3/4.2.3 MINIMUM CRITICAL POWER RATIO

3.2.3. The MINIMUM CRITICAL POWER RATIO (MCPR) shall be:

MAXIMUM AVERAGE PLANAR LINEAR HEAT GENERATION RATE (MAPLHGR) VERSUS AVERAGE PLANAR EXPOSURE  
 GE FUEL TYPES 8CR233 (2.33% ENRICHED)  
 FIGURE 3.2.1-1

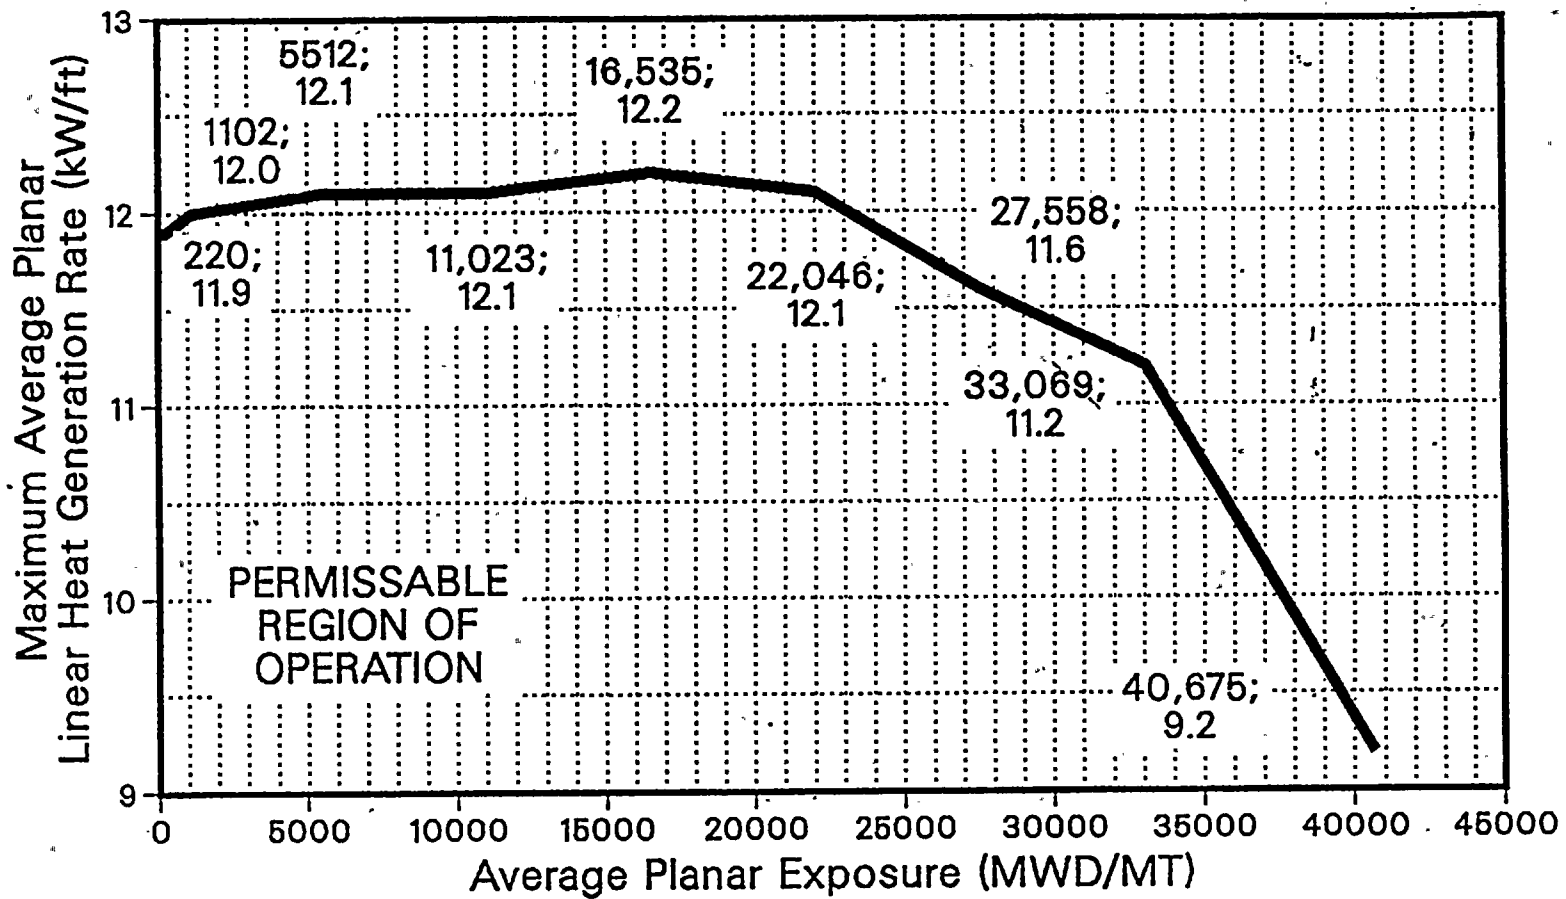
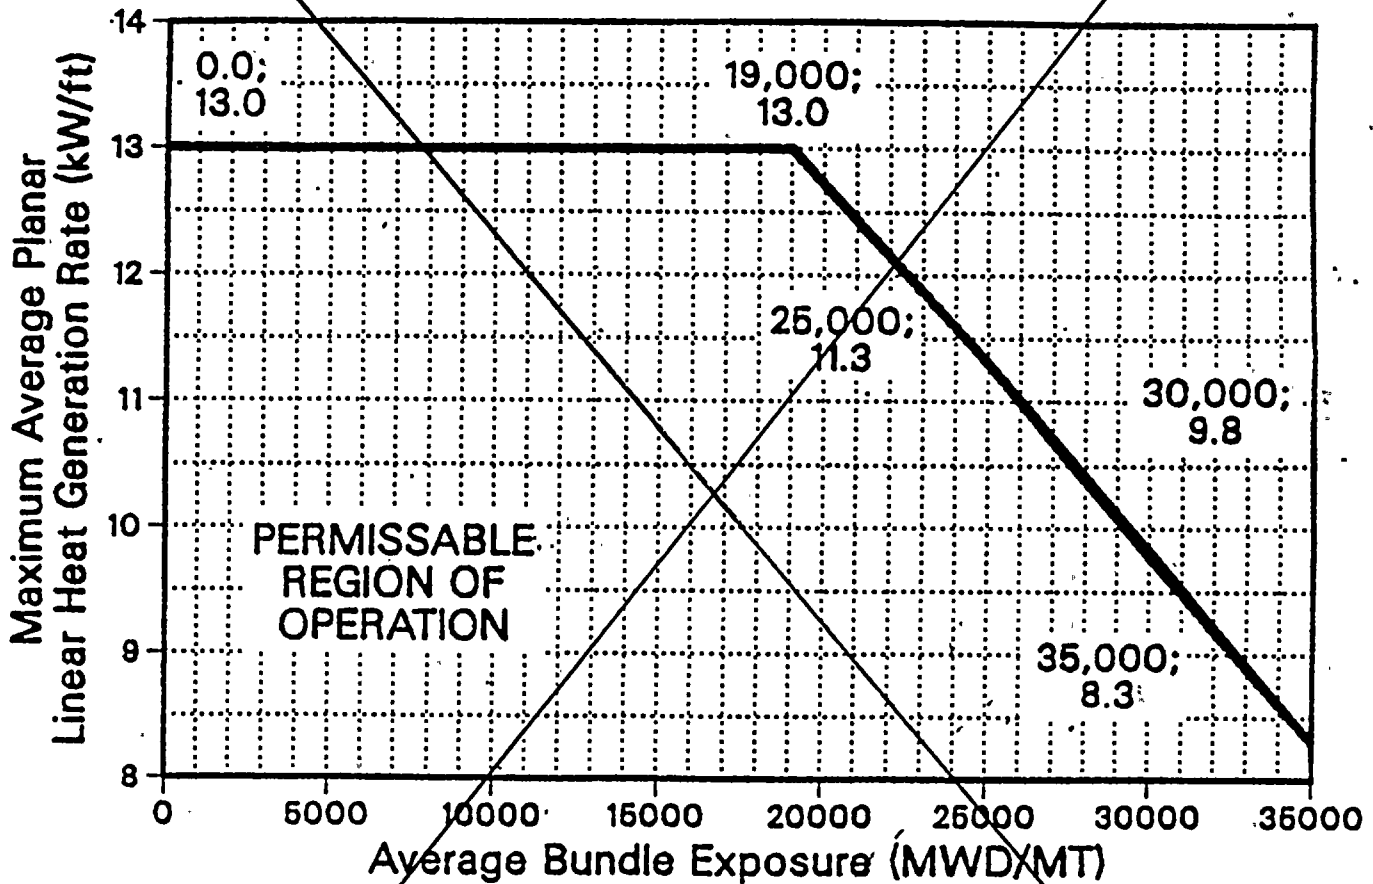
Replace with revised  
figure 3.2.1-1

MAXIMUM AVERAGE PLANAR LINEAR HEAT  
GENERATION RATE (MAPLHGR) VERSUS  
AVERAGE BUNDLE EXPOSURE  
EXXON 8X8 FUEL  
FIGURE 3.2.1-2

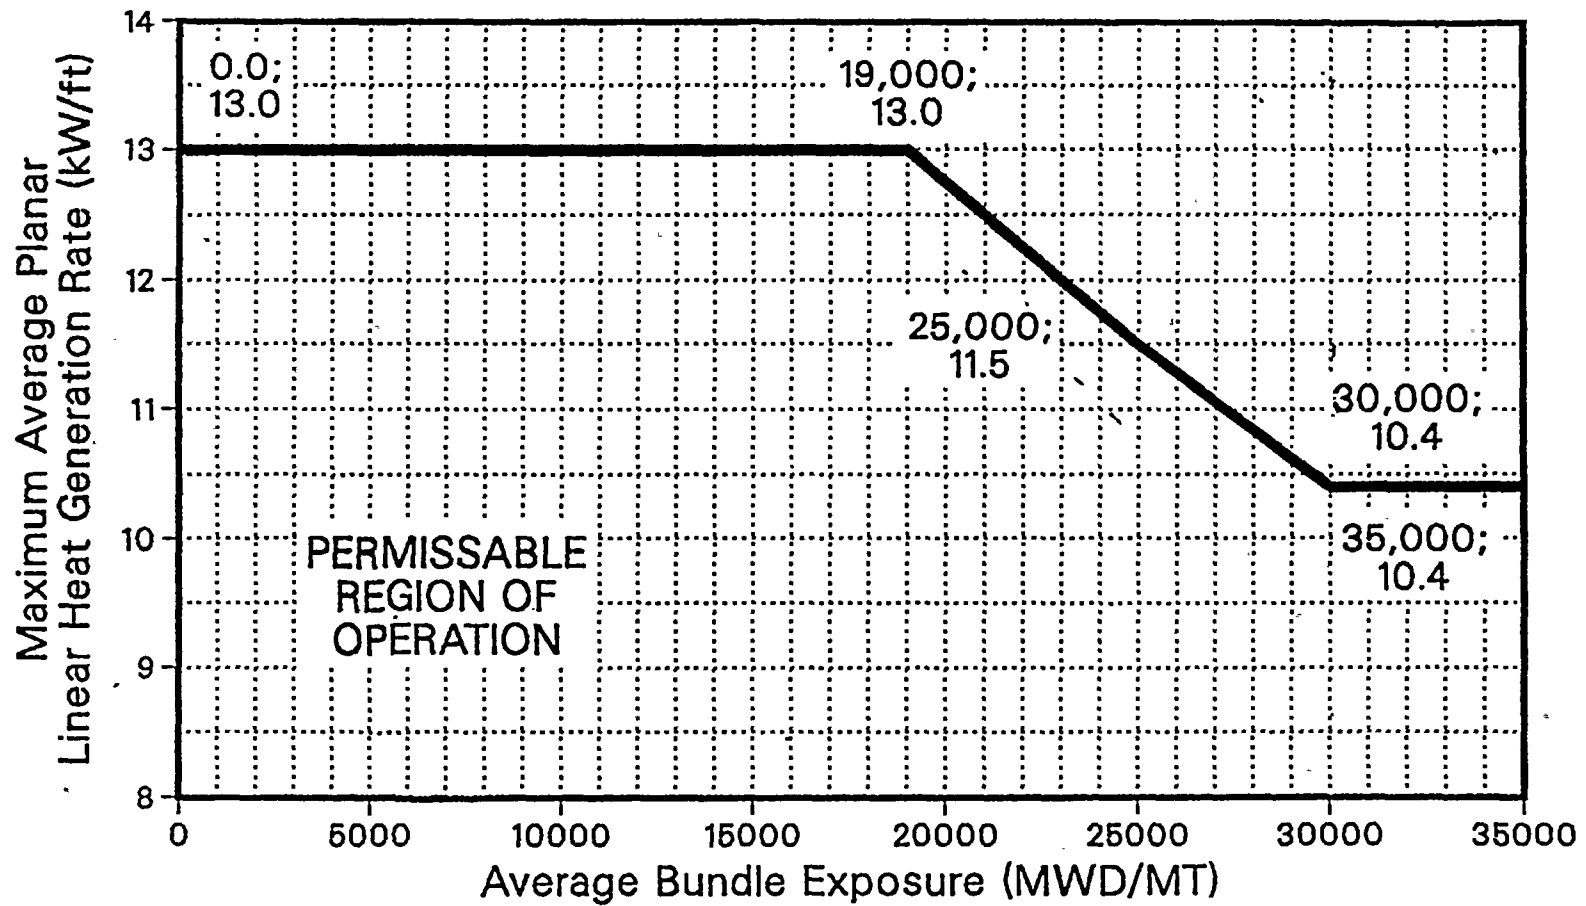
Replace with revised  
Figure 3.2.1-2

REDUCED FLOW M CPR OPERATING LIMIT  
FIGURE 3.2.3-1

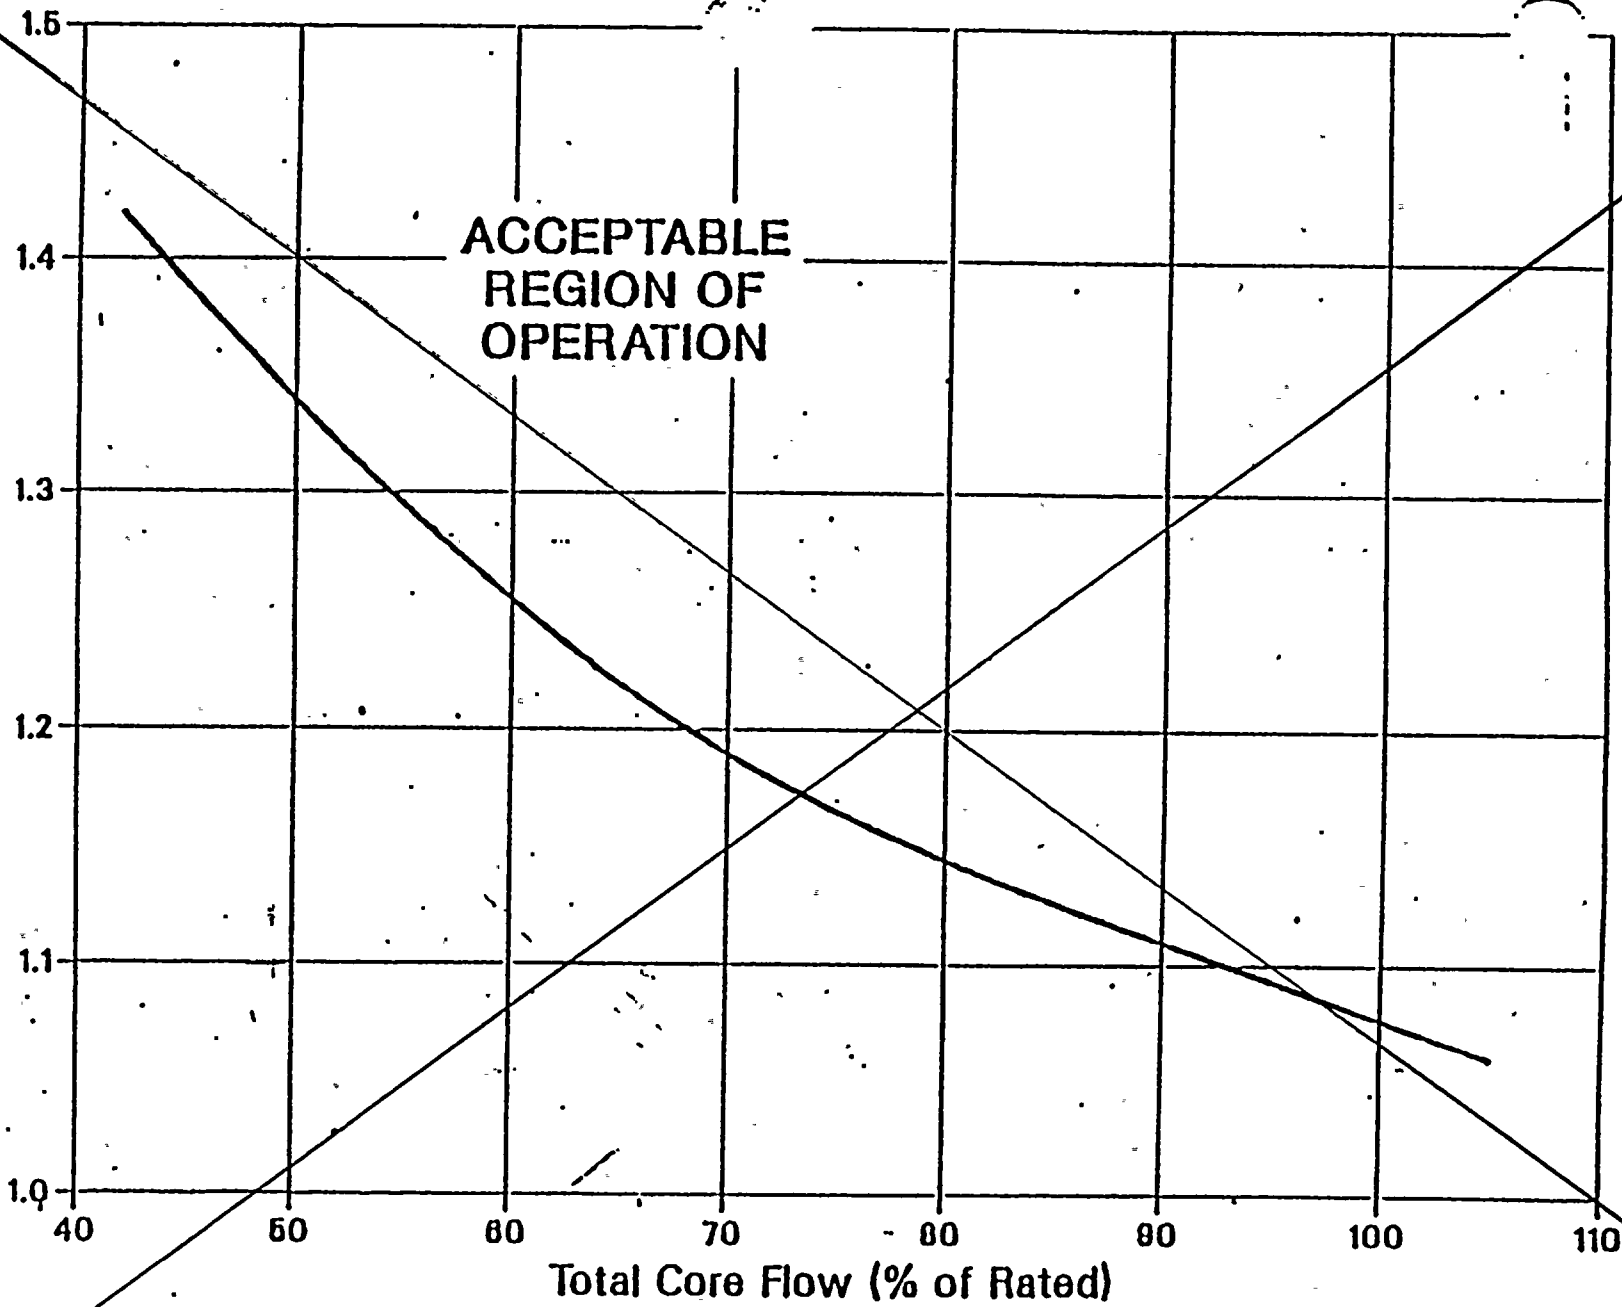
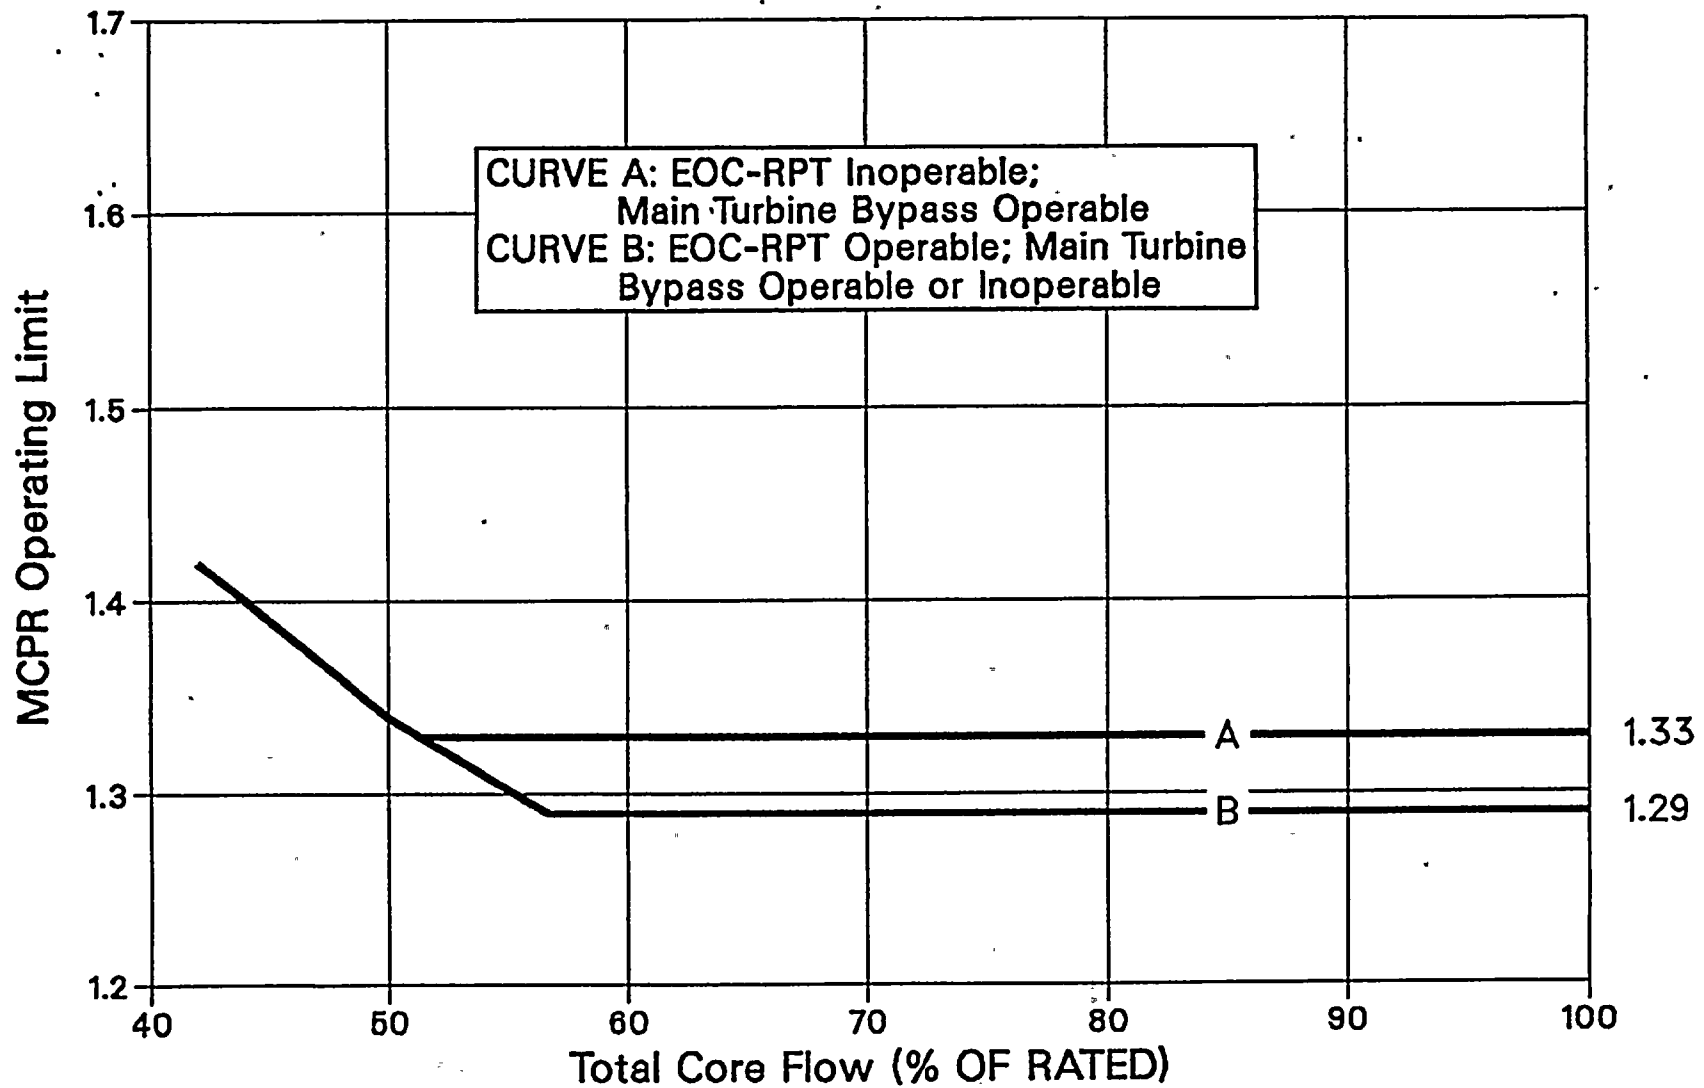
Replace with  
revised Figure 3.2.3-1

**FLOW DEPENDENT MCPR OPERATING LIMIT  
FIGURE 3.2.3-1**

Figure 3.2.3-2

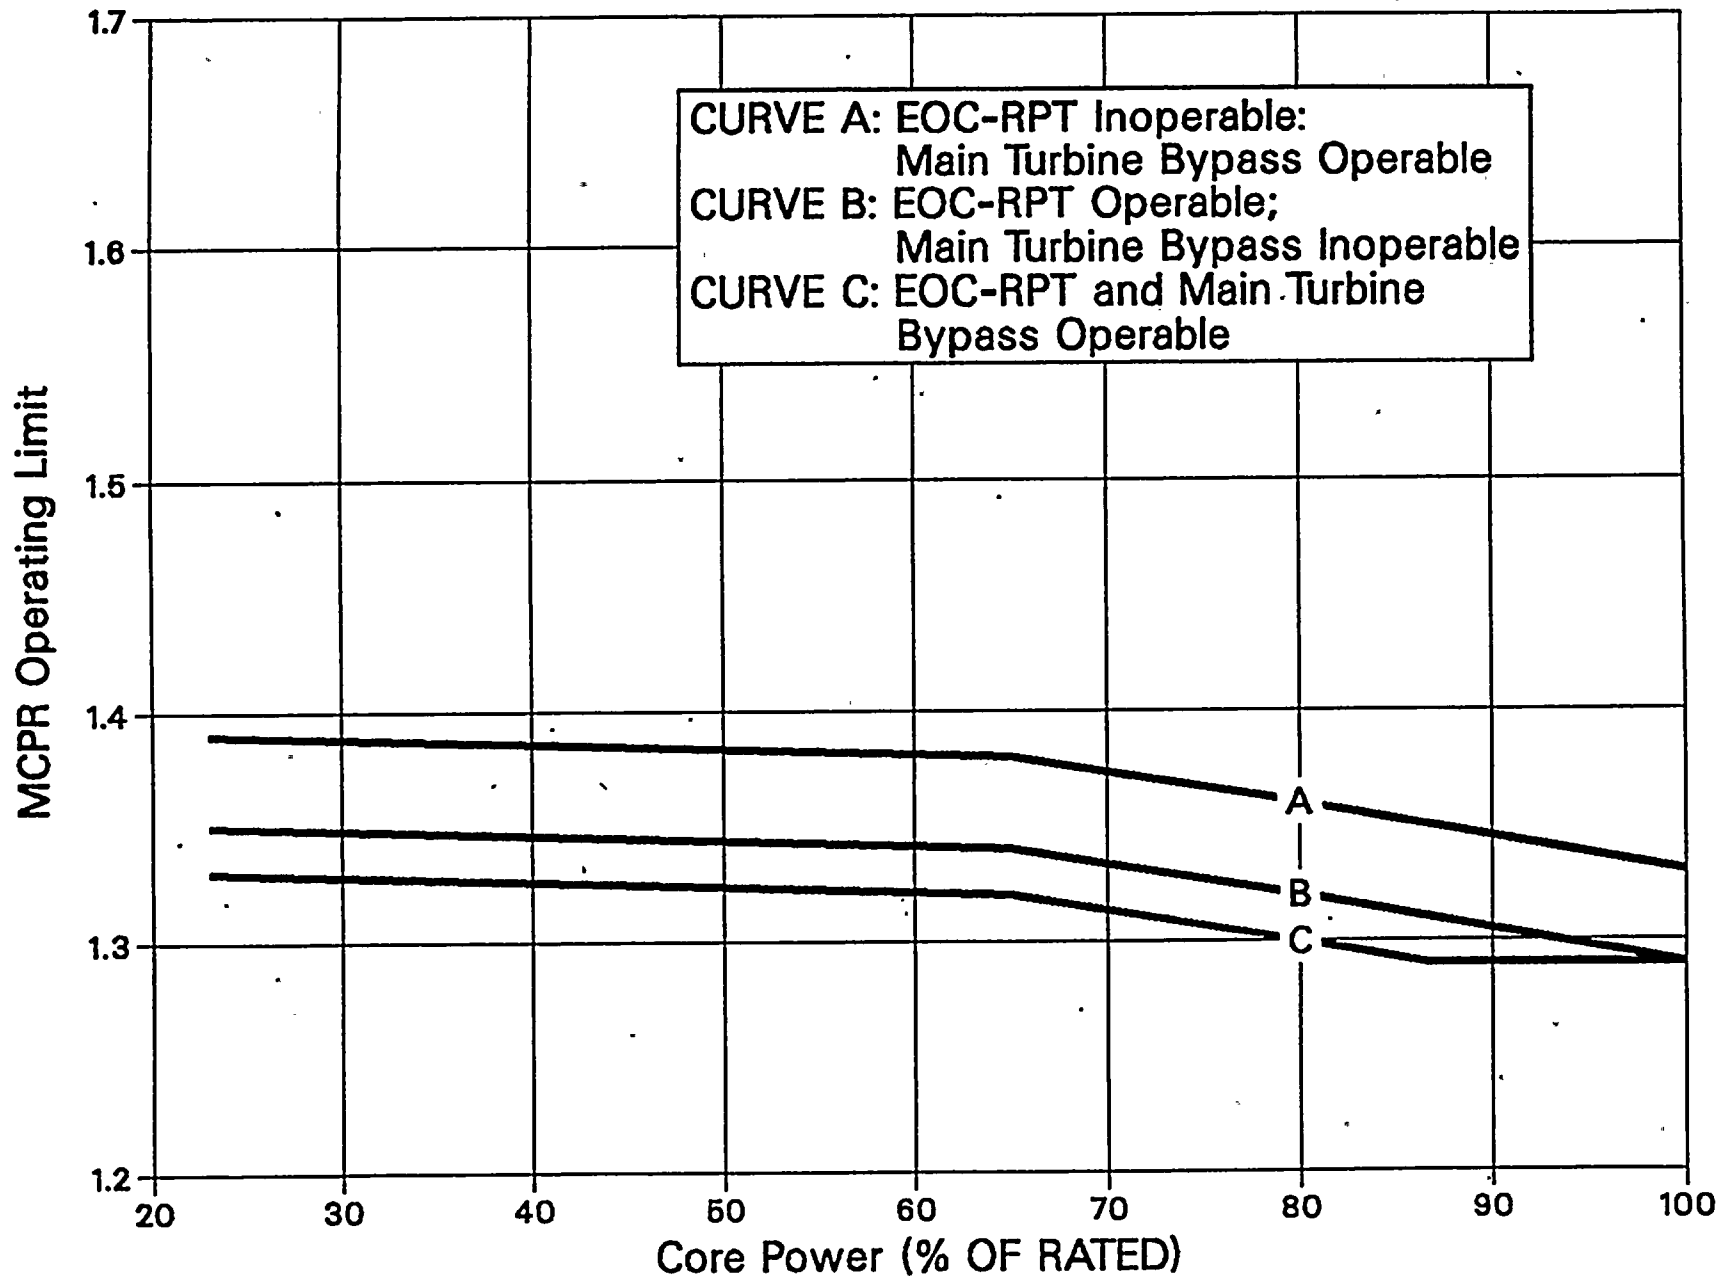
4.2.3.1 MCPR shall be determined to be greater than or equal to the applicable MCPR limit determined ~~from Table 3.2.3-1 and Figure 3.2.3-1~~ <sup>from Figure 3.2.3-1 and Figure 3.2.3-2:</sup>

Figure 3.2.3-1 defines core flow dependent MCPR operating limits which assure that the Safety Limit MCPR will not be exceeded during a flow increase transient resulting from a motor-generator speed control failure. The flow dependent MCPR is only calculated for the manual flow control mode. Therefore, automatic flow control operation is not permitted. Figure 3.2.3-2 defines the power dependent MCPR operating limit which assures that the Safety Limit MCPR will not be exceeded in the event of a feedwater controller failure initiated from a reduced power condition.
